## CPED STAFF REPORT

Prepared for the Heritage Preservation Commission  
HPC Agenda Item #3  
July 28, 2015  
BZH-28744

*Property Location:* 200 1<sup>st</sup> Street North  
*Project Name:* 200 1<sup>st</sup> Street North  
*Prepared By:* Aaron Hanauer, Senior City Planner, (612) 673-2494  
*Applicant:* The Daft Group, Eric Dayton  
*Project Contact:* James Dayton Design, Robert Hunter  
*Ward:* 3  
*Neighborhood:* North Loop  
*Request:* To rehabilitate the Northwestern Hide and Fur Building  
*Required Applications:*

<b>Certificate of Appropriateness</b>	To allow the rehabilitation of the Northwestern Hide and Fur Building
---------------------------------------	---

200 FIRST STREET NORTH - ELEVATION OF PROPOSED DOOR AND WINDOWS

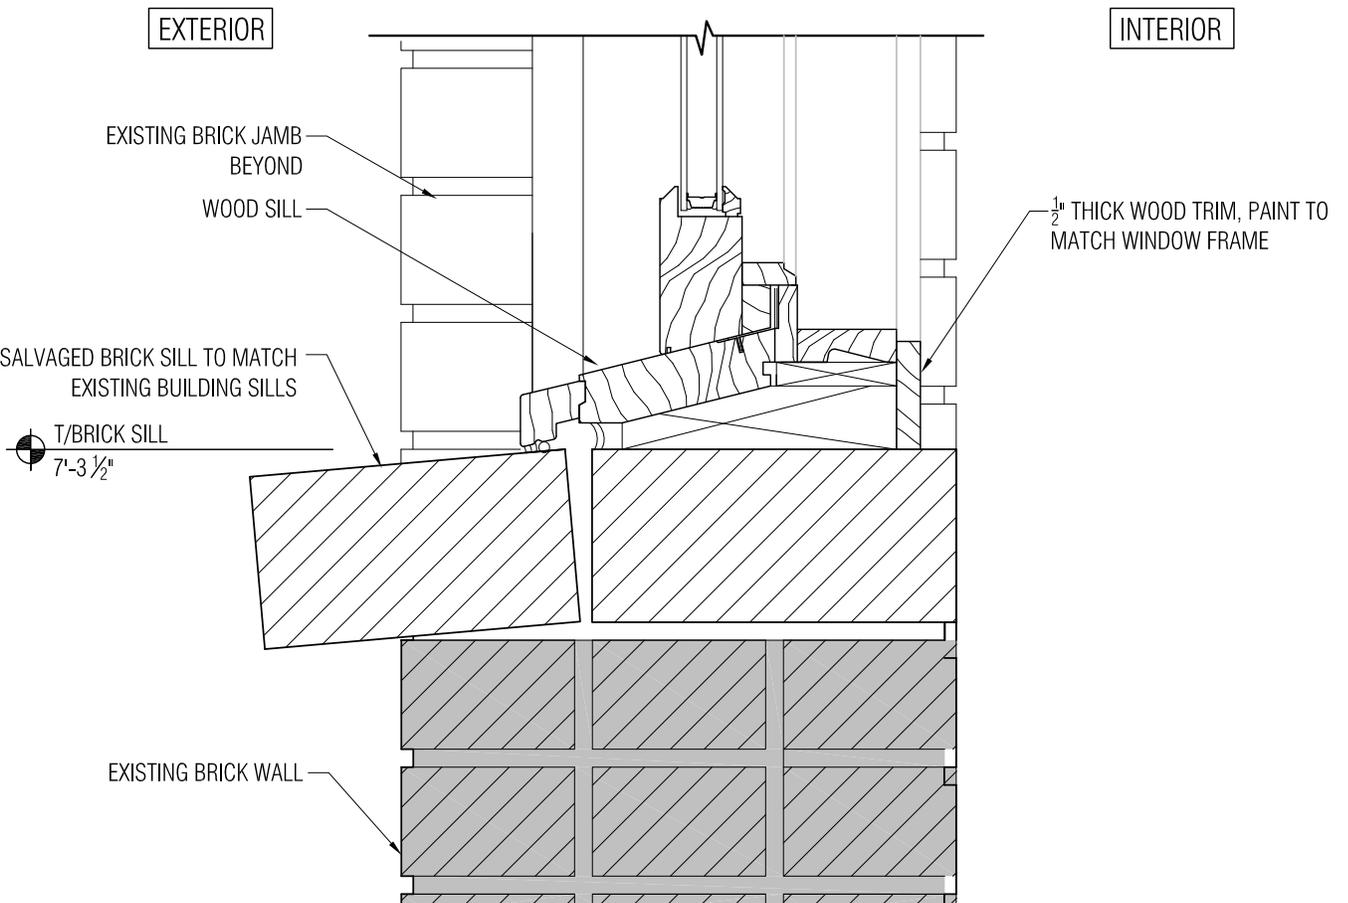
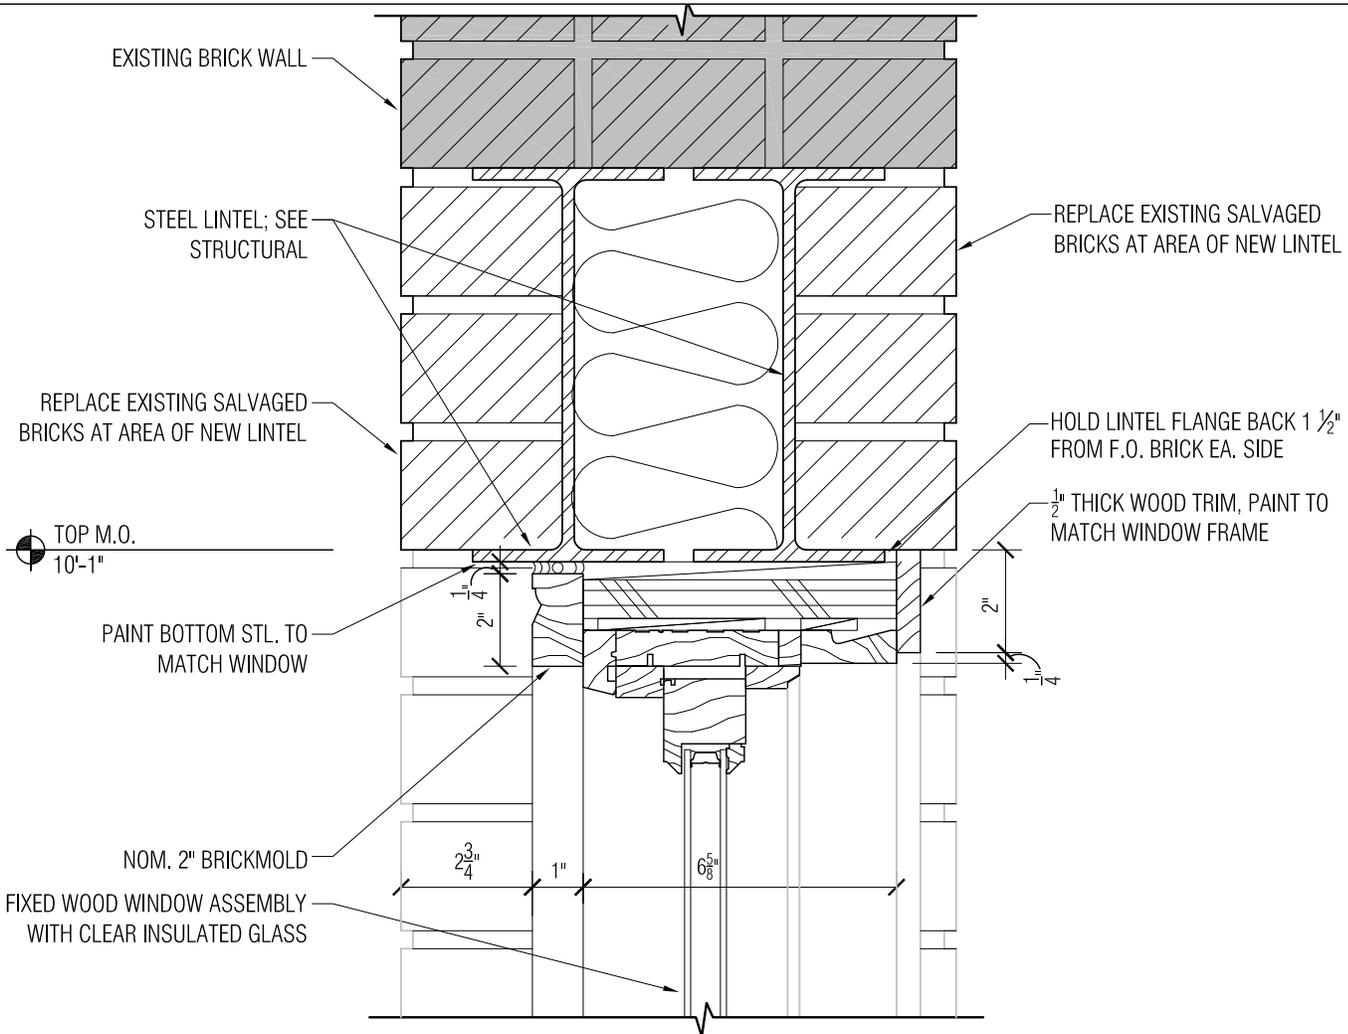
The only modification to the building's window fenestration is the proposal to install two horizontally-oriented, wood windows on the north elevation. The windows would be

approximately 19 square feet (6.8 feet wide by 2.8 feet tall). Brick sills would be constructed out of brick salvaged from creating the window openings. The windows would have the same profile and color as the windows installed during the 2011 restoration/rehabilitation.

The applicant is not proposing to install a brick arch above the new windows. All original window openings on the Northwestern Hide and Fur Building have a masonry arch above the windows. The arches on the original construction (1881) at the corner of 1<sup>st</sup> Street North and 2<sup>nd</sup> Avenue North have a segmental arch with projecting hood. The arches in the 1902 building addition are flat segmental arches.

It is recognized that the applicant's rehabilitation proposal to not impact original window openings is consistent with the district guidelines. It is also recognized that the district guidelines allow flexibility in allowing new openings on secondary facades. However, given the visibility of the proposed windows from 1<sup>st</sup> Street North, CPED is recommending that the applicant install a flat segmental brick arch above the new windows to help the new windows blend in better with existing windows and that the applicant shall use the brick salvaged from creating the new openings for the arches. By having the segmental arch it will help the new windows blend in better with the existing window openings on the north and east (front) elevations that have brick arches.

A flat segmental arch above the new windows will not confuse what is original construction from what is new construction as the 1881 building has windows with projecting hoods while the 1902 building addition has flat segmental arches; the new windows would be located in the 1881 building portion of the building. In addition, the new windows will stand out as contemporary windows as they will be the only horizontally oriented windows on the building, and the applicant is proposing a brick sill while the original windows on the building (both the 1881 and 1902 portions) have stone sills.

The applicant is proposing to install one door on the north façade to connect the café to the pocket park and to meet the building code requirement of having a second means of egress. The proposed wood door will match the details of the 1<sup>st</sup> Street North door that was installed as part of the 2011 rehabilitation project in terms of design, finish, and size. It will have six divided lights above and two panels below. Lintels will be entirely concealed within the existing wall. The applicant is proposing to have the removed brick from the created opening salvaged and stored onsite. The applicant's entryway proposal meets the applicable district guidelines. The applicant is proposing to retain the original and historically significant pedestrian entrance opening on the

east elevation (1<sup>st</sup> Street North) and to use this entrance as the building's primary entrance. The proposed door will meet the district design guidelines in terms of a simple design, with an open transparent glass.

## 200 FIRST STREET NORTH - VINE PLANTING AREA

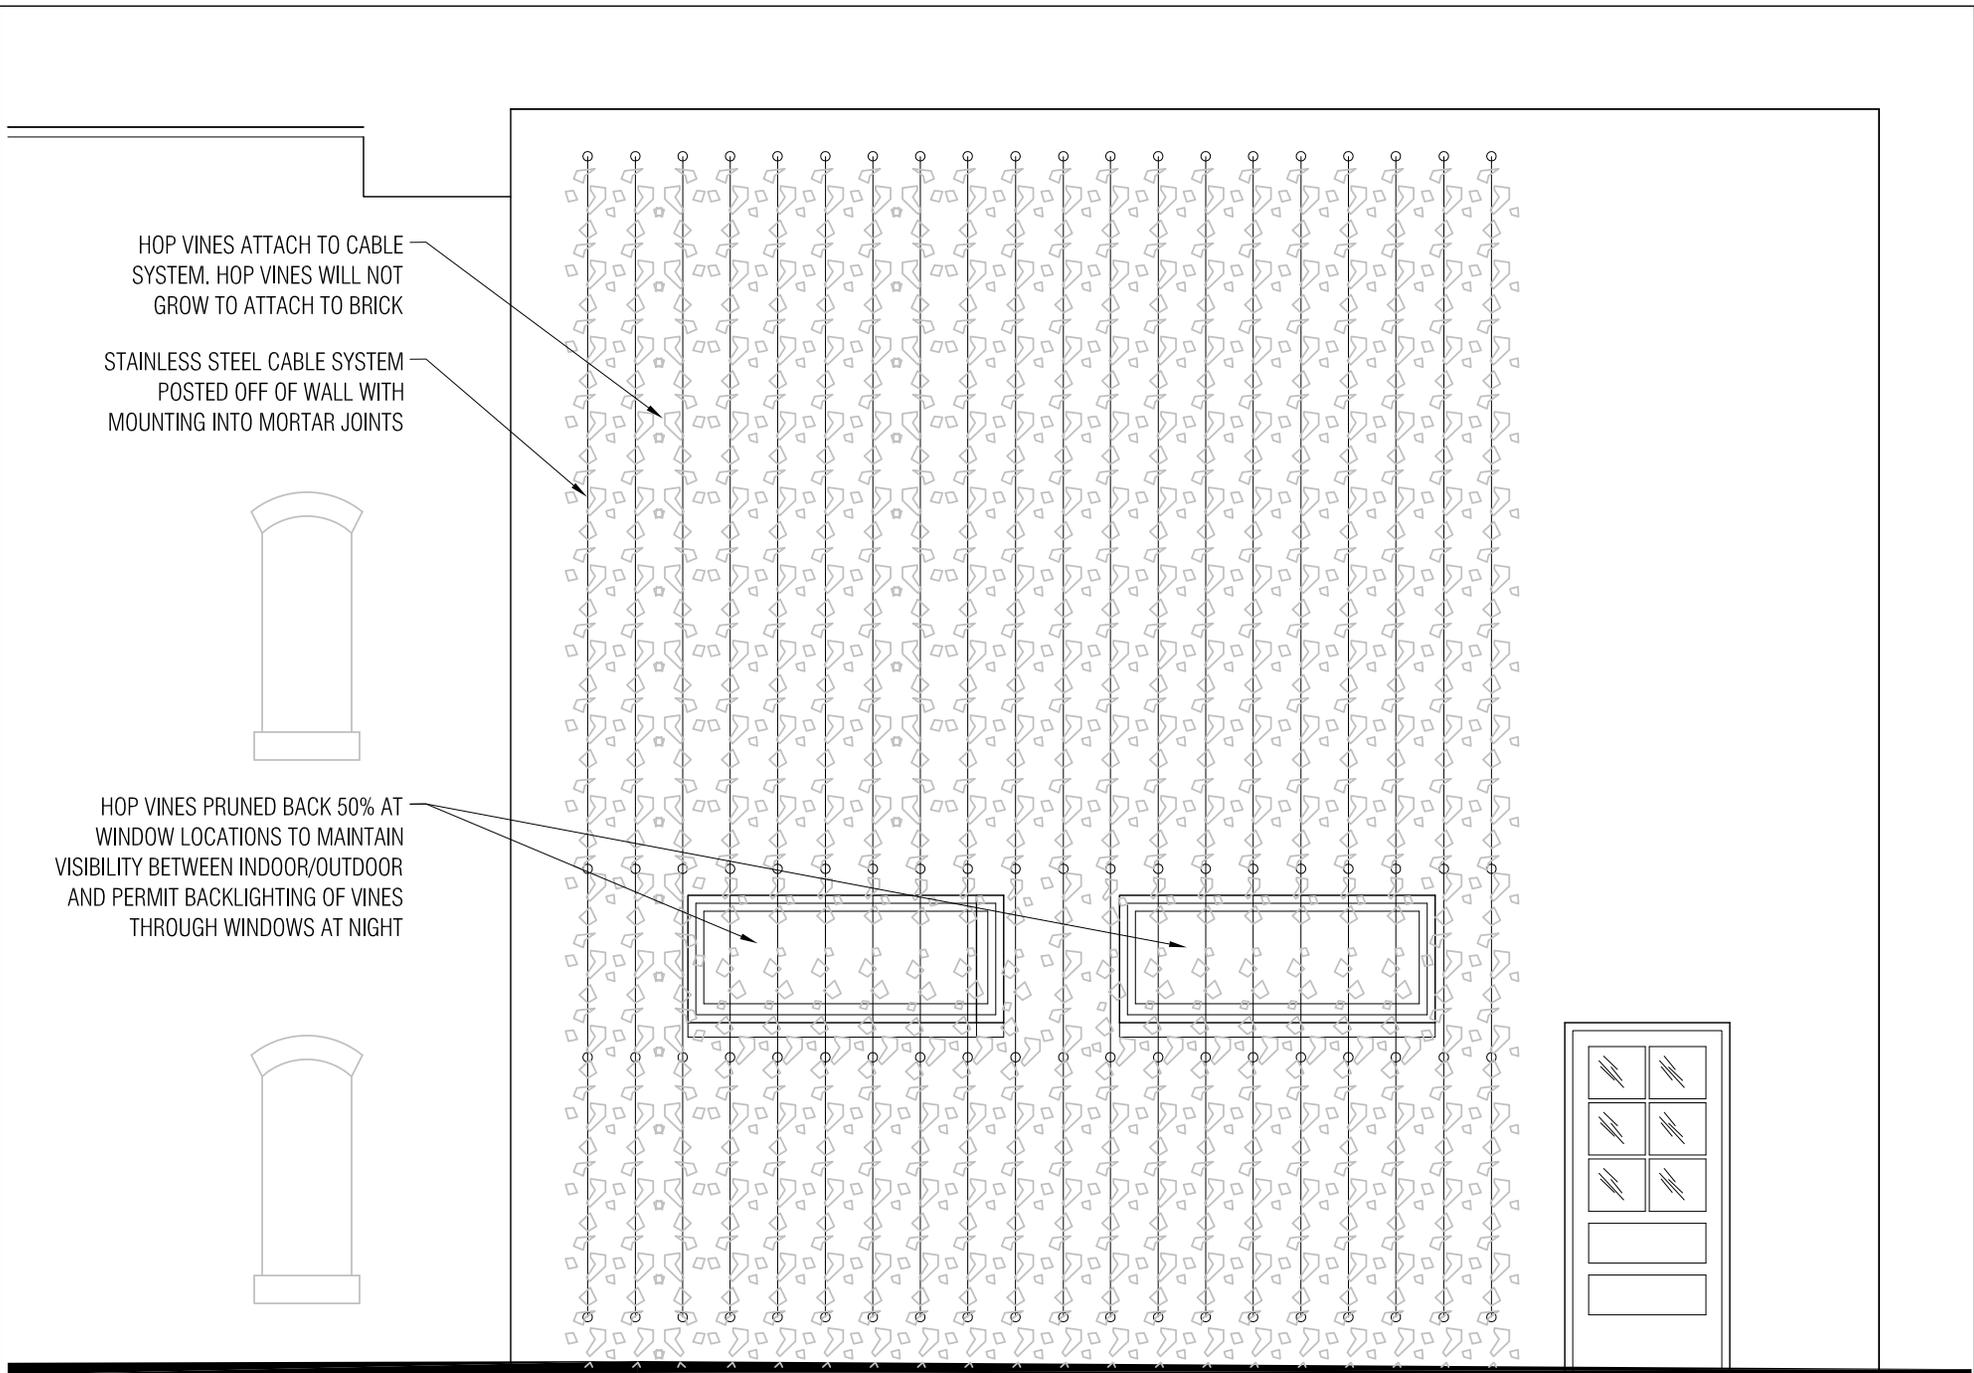
The applicant is also proposing to install a green planting wall for 20 linear feet on the north elevation facing the building at 206 1<sup>st</sup> Street North; the green wall would be located eight feet back from the 1<sup>st</sup> Street North elevation. It would accommodate the growing of hop vines. The applicant points out that hop vines grow and climb by wrapping around a trellis and will not attach to the brick wall. The trellis wall will be installed within existing mortar joints. The applicant estimates there will be approximately 80 attachments between the planting wall and the building's masonry wall.

The proposed trellis wall is in compliance with the district guidelines as it is not located on a character defining façade, is limited in size to preserve the relationship of the existing building, and is reversible without adversely impacting the building's masonry. CPED agrees with the applicant's statement that the green planting wall will complement the pocket park that is proposed between the subject building and the building at 206 1<sup>st</sup> Street North.

200 FIRST STREET NORTH:  
 PLAN OF EXISTING AND PROPOSED TRASH ENCLOSURE

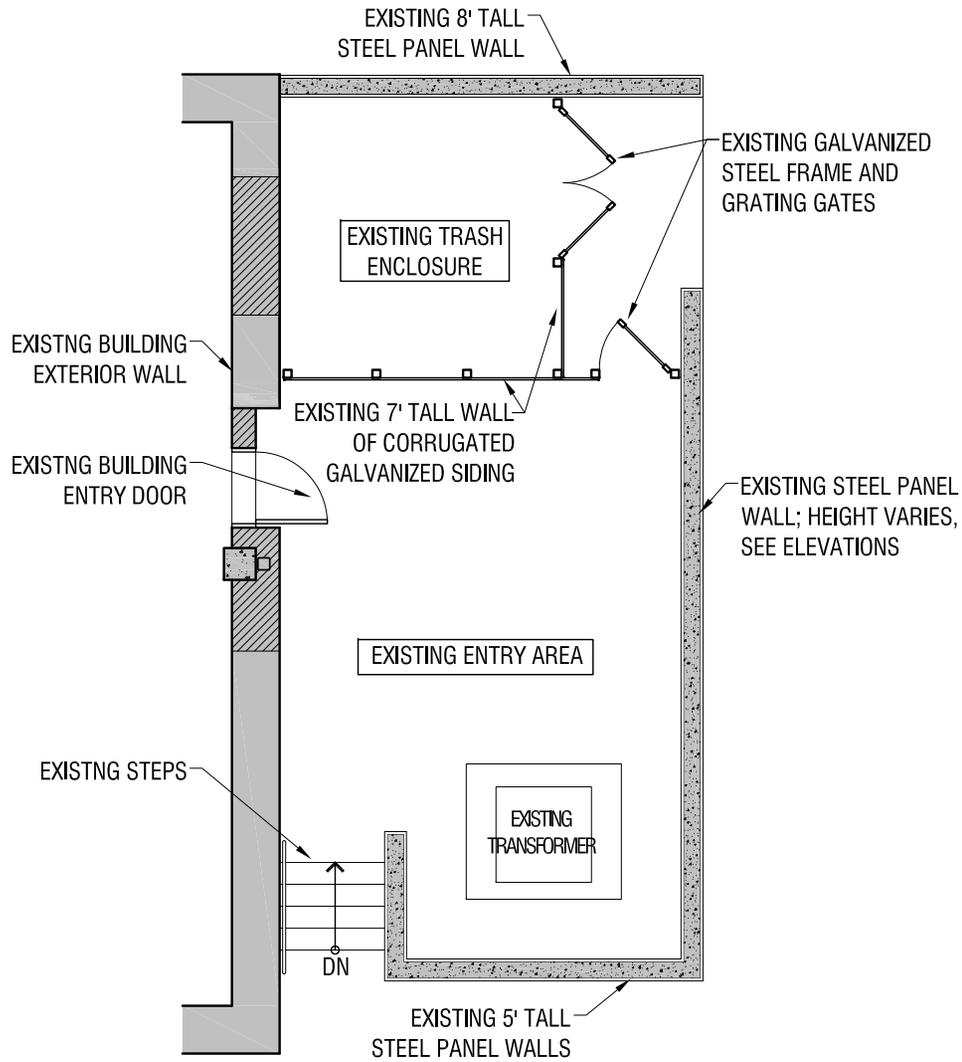
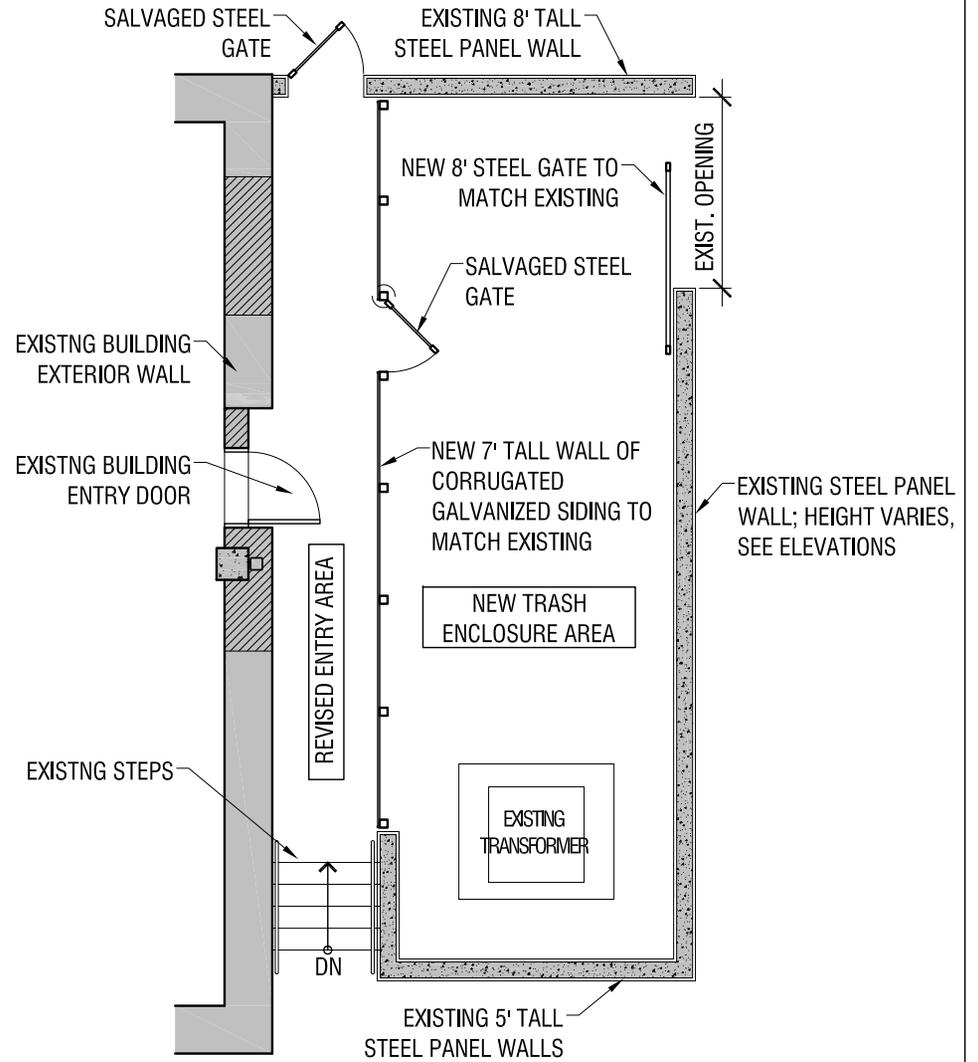
At the east end (rear) of the building there is a depressed enclosed area that provides an entrance to the Marvel Bar, located on the lower level of the building, and accommodates trash storage. The trash area is currently along the north end of the enclosure. The building entrance is screened from the trash area by an anodized ribbed steel panel. The applicant is proposing to remodel the trash area within the enclosed area to provide additional storage space by expanding it the length of the western wall. This is proposed to accommodate increased trash storage demands generated by the new café and kitchen uses. The trash area is proposed to be screened from the bar entrance with a similar metal (anodized ribbed steel panel) wall that is currently there.

# 200 FIRST STREET NORTH - ROOF PLAN

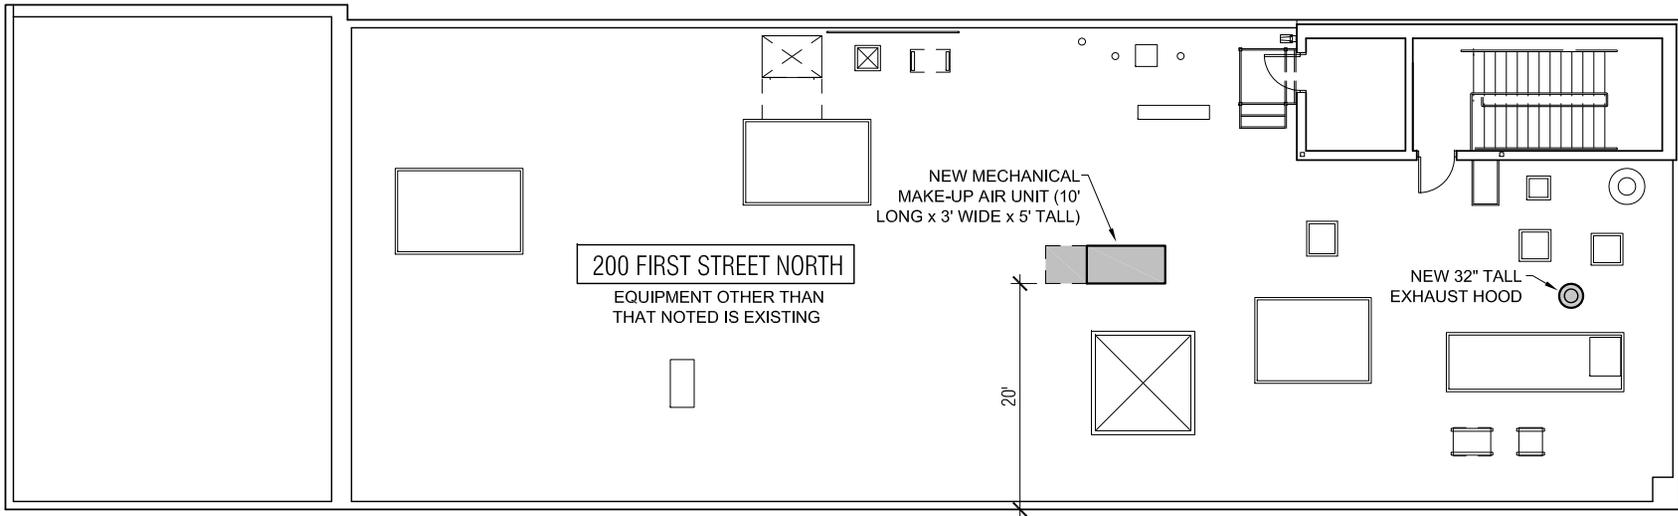
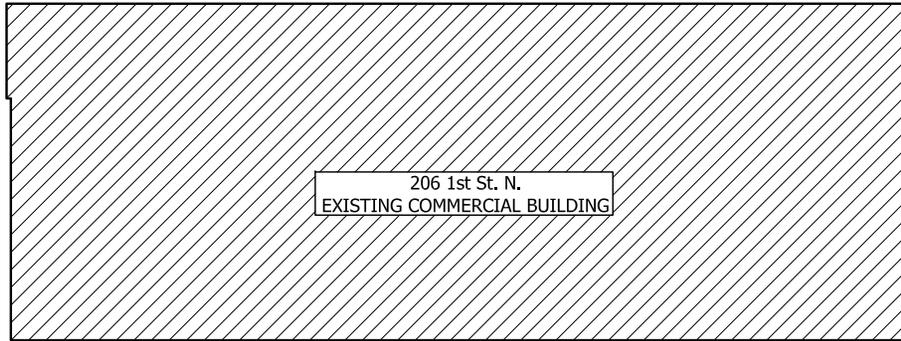
The applicant is proposing a make-up-air unit on the rooftop to accommodate the service demands of the new kitchen on the second floor. This unit would be 10 feet long by three feet wide and five feet tall. It would be located a minimum of 20 feet from the side of the building and behind existing mechanical equipment. The new equipment will be in compliance with the district guideline requirements in terms of height. Given the proposed location of the new mechanical equipment and the location and height of existing mechanical equipment, the new equipment will not be visible from the street.
